To: Kristopher Byrd, Well Construction Section Manager
From: Tommy Laird, Well Construction Program Coordinator
Subject: Review of Water Right Application G-19162
Date: October 18, 2023

Groundwater Application Review Summary Form

Application # G- 19162

PUBLIC INTEREST REVIEW FOR GROUNDWATER APPLICATIONS

Well Statistics

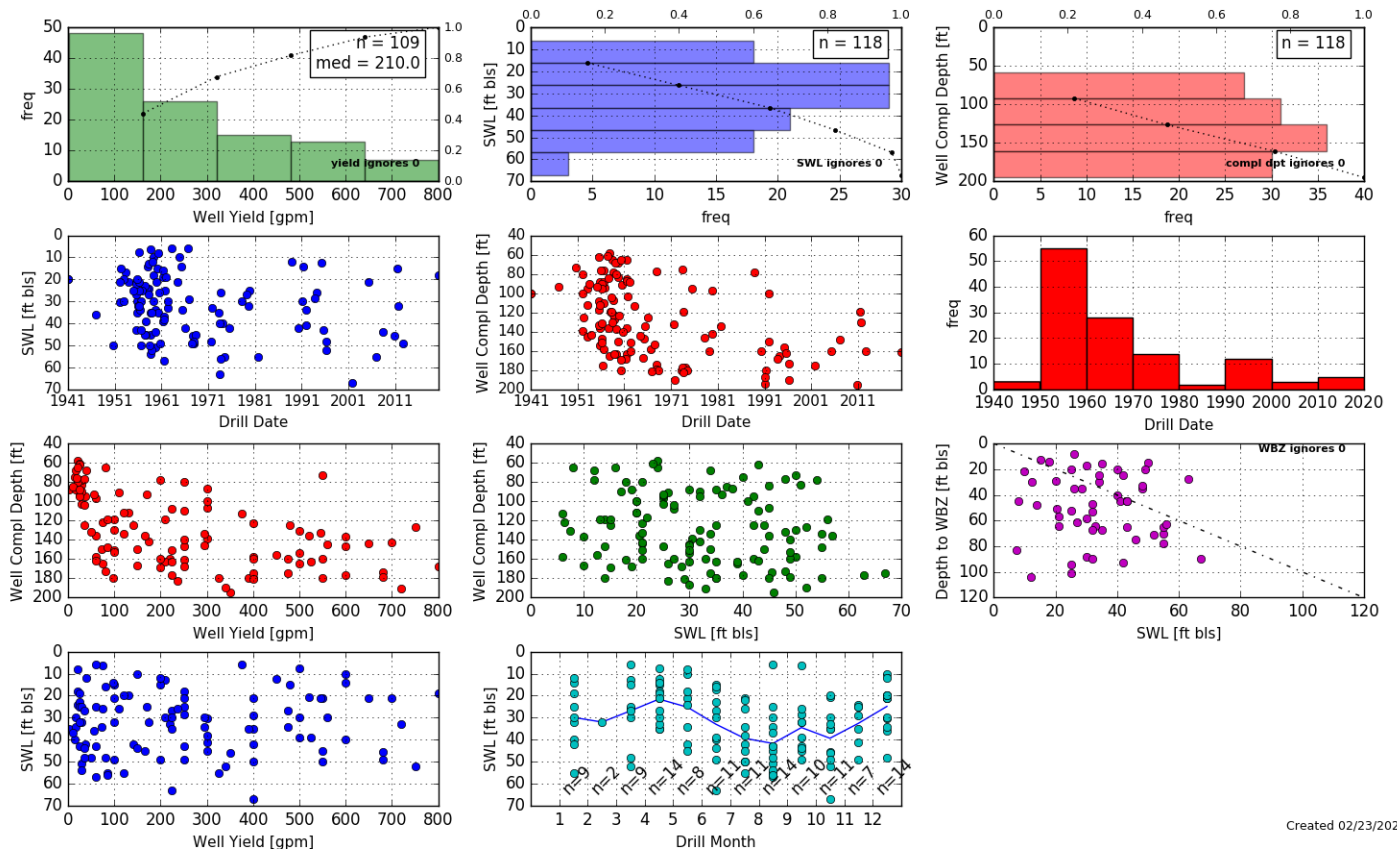
A review of statistics for nearby alluvial well records was completed and compared with the proposed rate of 0.10 cfs (44.88 gpm) for this application (see Well Statistics). The proposed rate of use of 0.10 cfs (44.88 gpm) is likely within the capacity of the groundwater resource; median reported well yield is 210 gpm, and the maximum reported yield is 800 gpm. The proposed rate for this application is 21% of the median and 6% of the maximum reported yield.

Water-Level Measurements in Nearby Wells

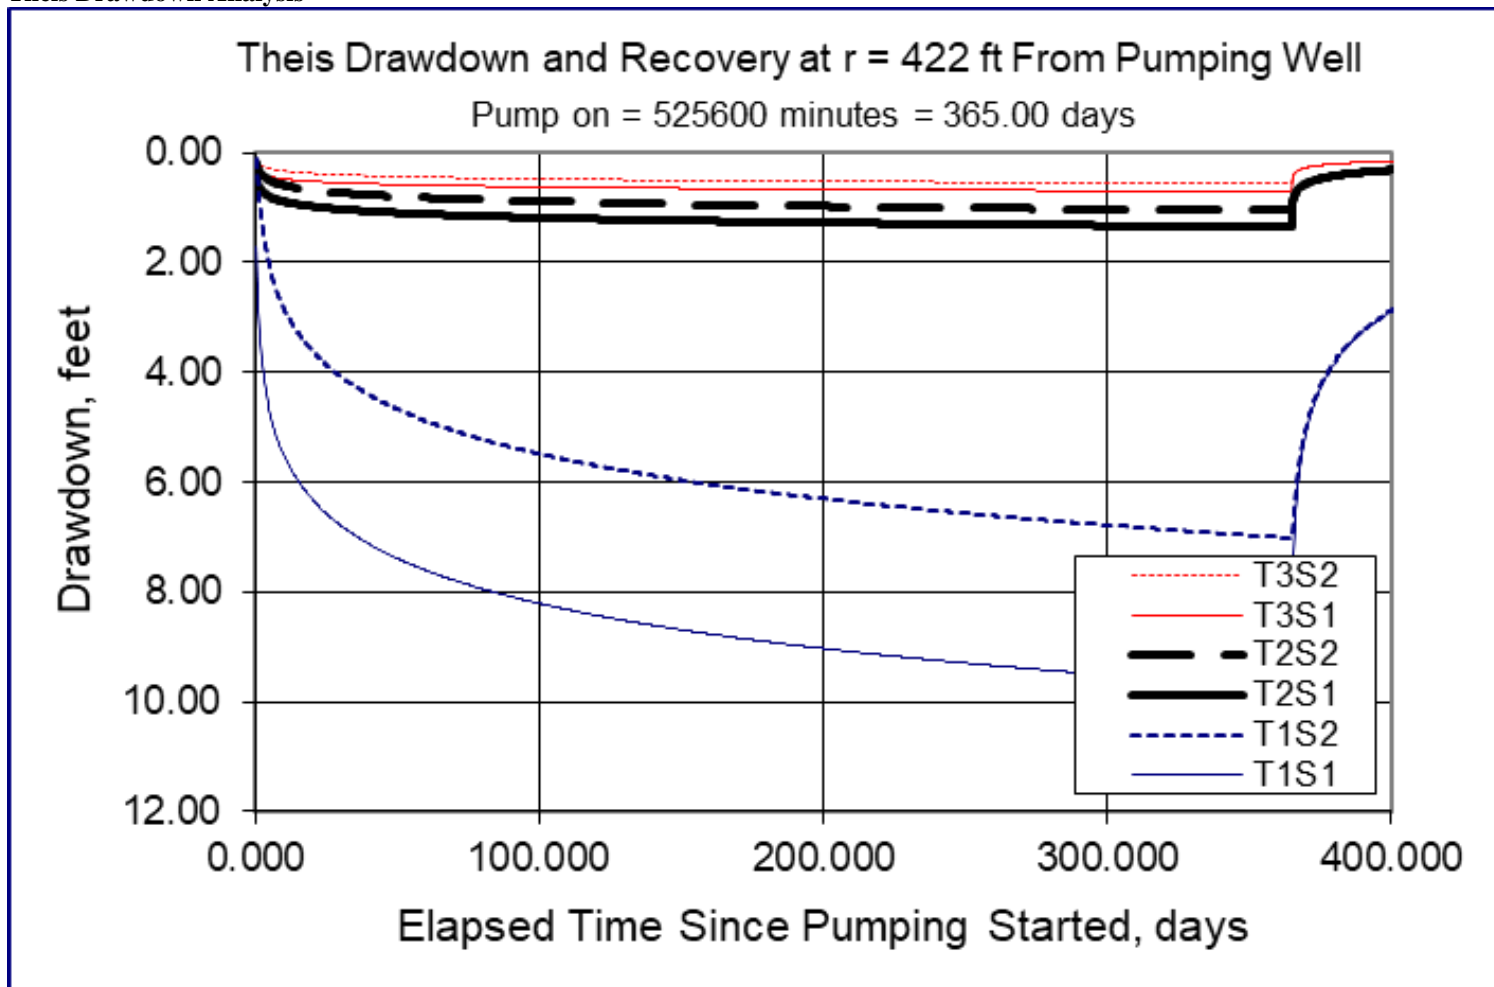
Water level trends for nearby (0.7 to 4 miles from POA) wells that utilize alluvial aquifers appear to be steady (see Water Level Measurements in Nearby Wells). Five of the wells included have experienced water level declines ranging from 3 to 5 ft over the last 10 years (MARI 17377, MARI 50474, MARI 50650, MARI 56474, MARI 63354); all of these wells utilize predominantly coarse water-bearing zones, ie sand and/or gravel, and the wells with the highest declines have yields greater than 300 gpm. The remaining 13 wells appear to have steady water levels.
